PLANNING AND DEVELOPMENT SERVICES STAFF REPORT

For Planning Commission Meeting of October 4, 2011

**SUBJECT: The Varsity Ann Arbor Planned Project Site Plan
(425 East Washington Street)
Project No. SP11-023**

VARSITY ANN ARBOR
SITE PLAN
OVERALL LANDSCAPE PLAN

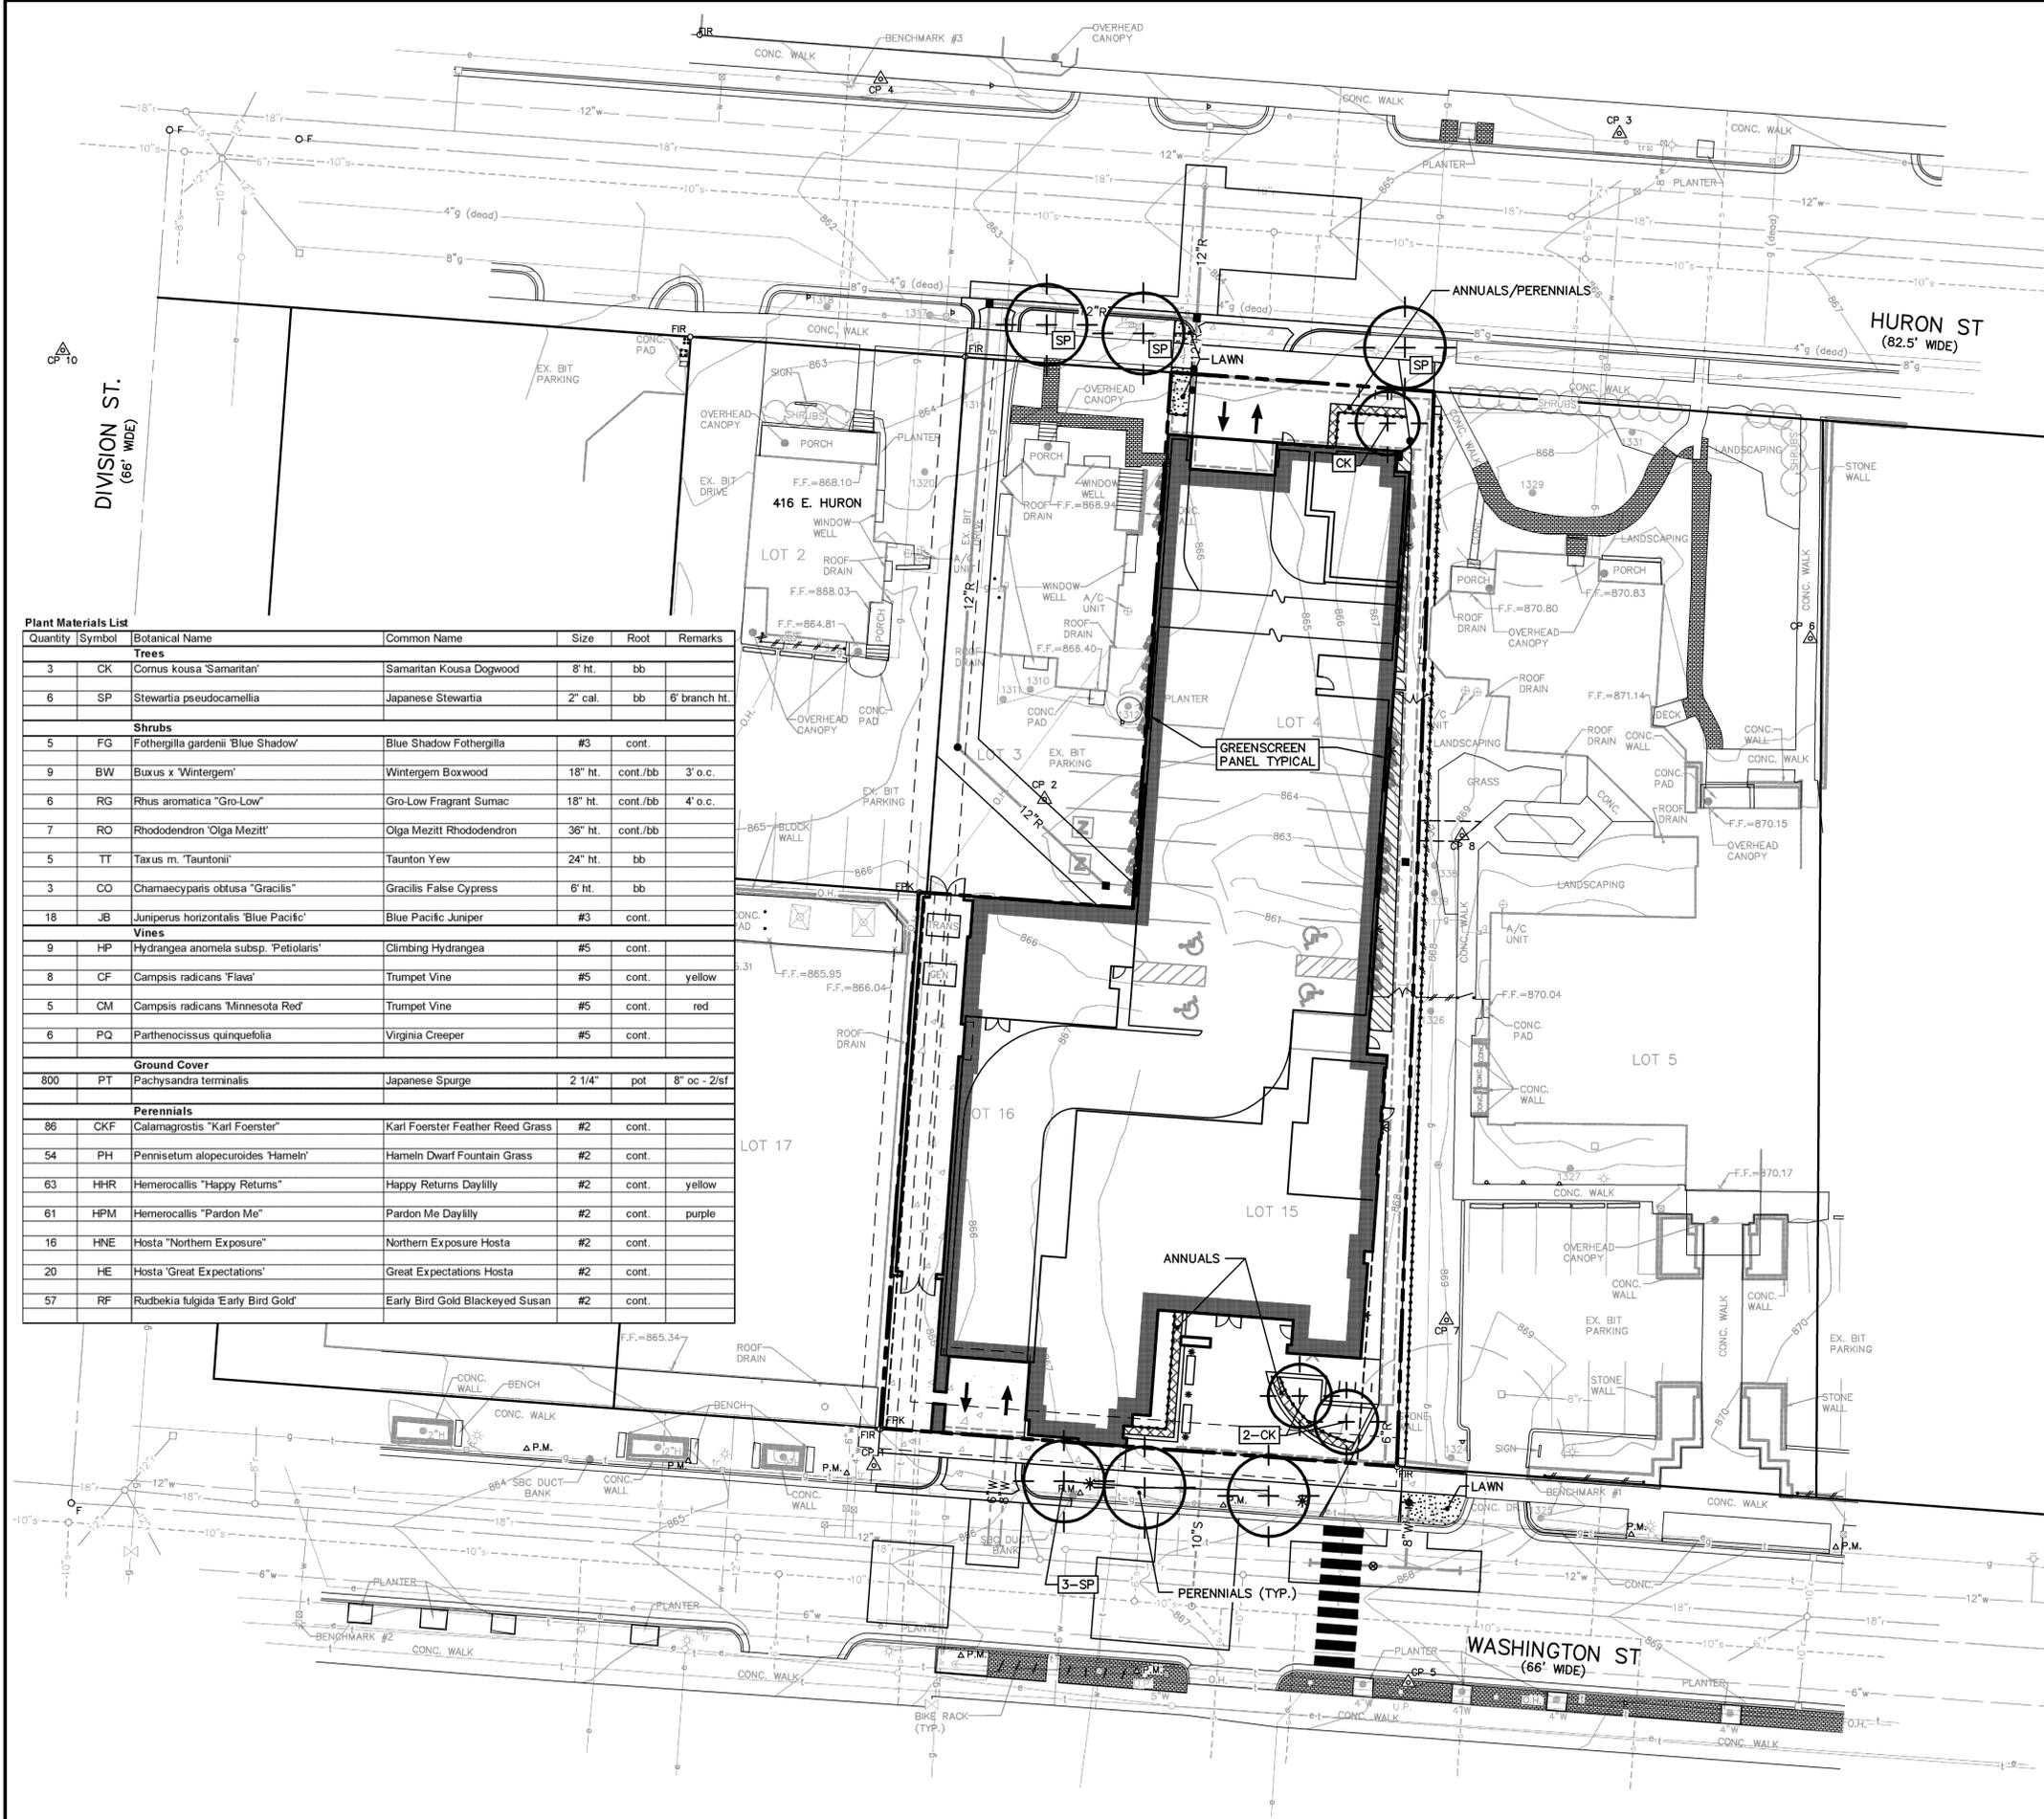
Plan Corrections and Preliminary Approval from Water Resources Commissioner – Corrections to the grading plan sheet and the landscape plans sheet requested by staff have been made. Preliminary plan approval for the storm water management system has been granted by the Washtenaw County Water Resources Commissioner's office.

A-03.02

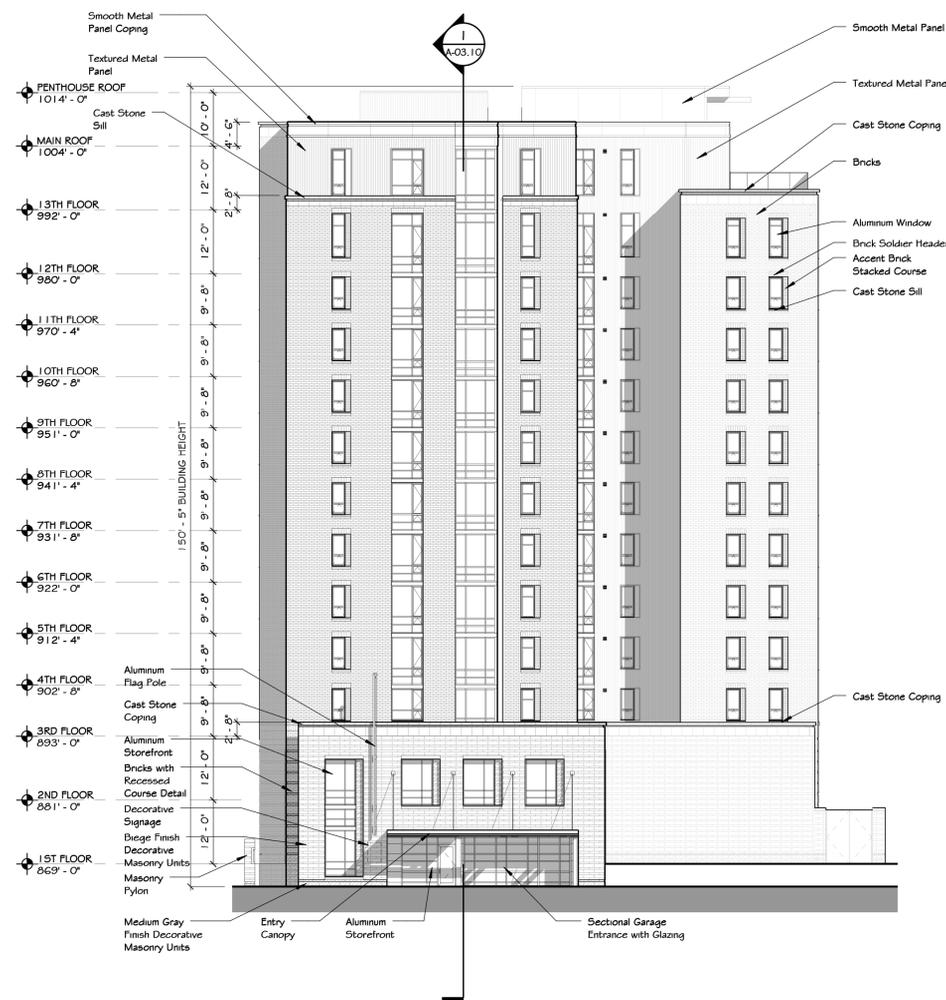
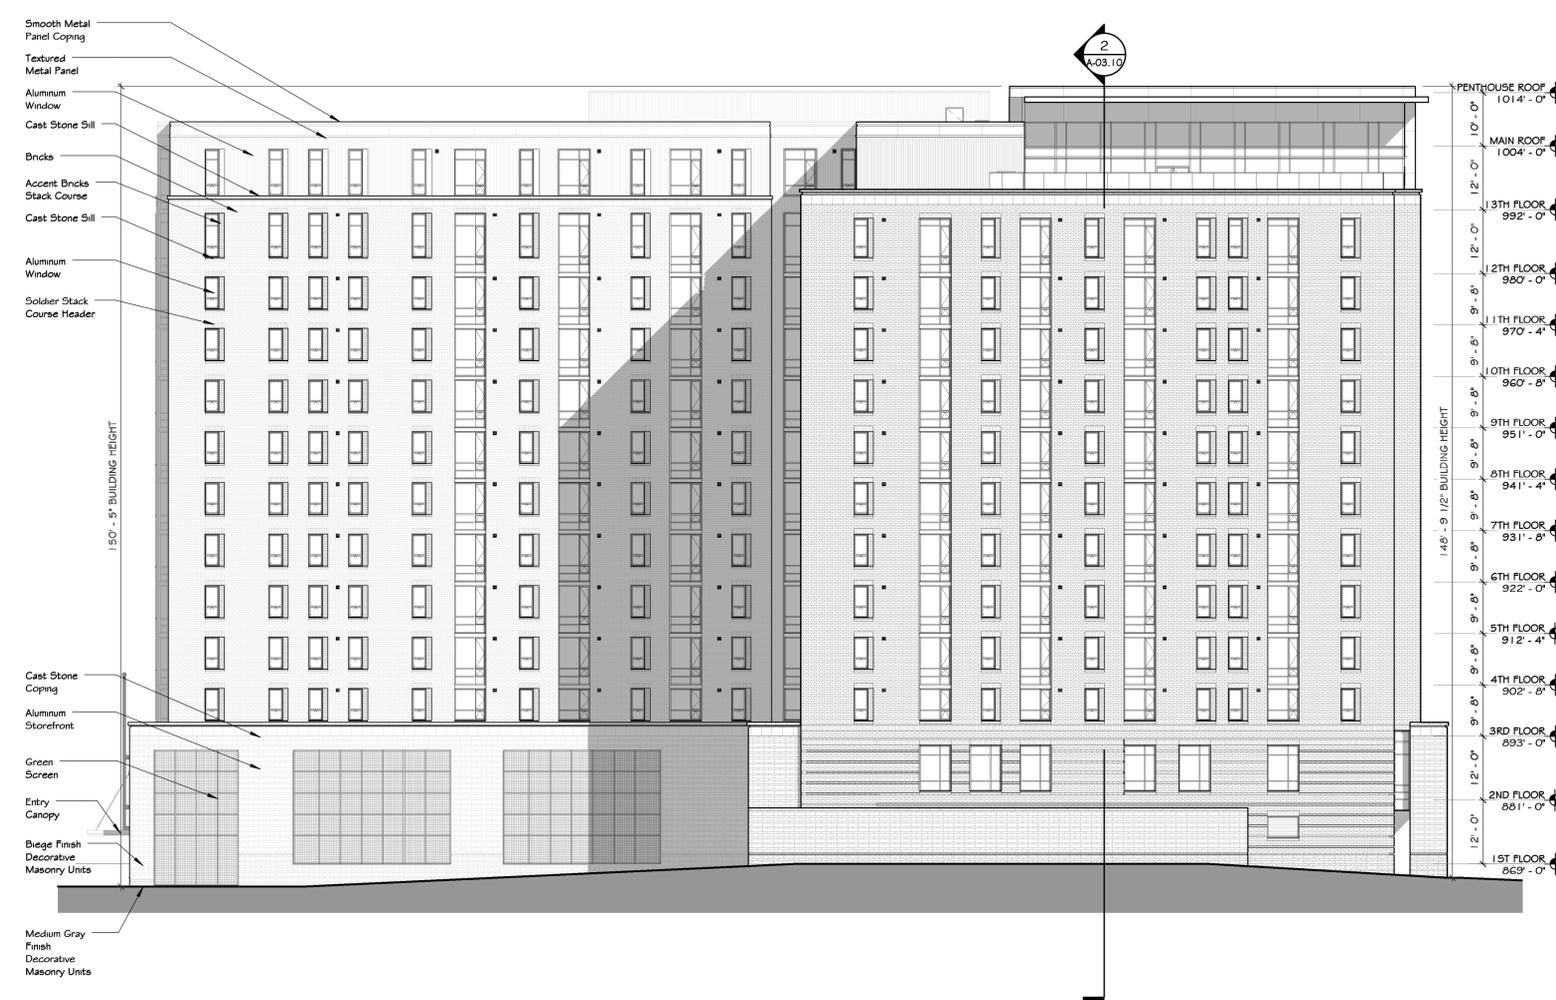
Two minor changes to the proposed architecture have been made, consolidating windows in the middle of the north façade and eliminating windows at the ground floor on the west facade. No
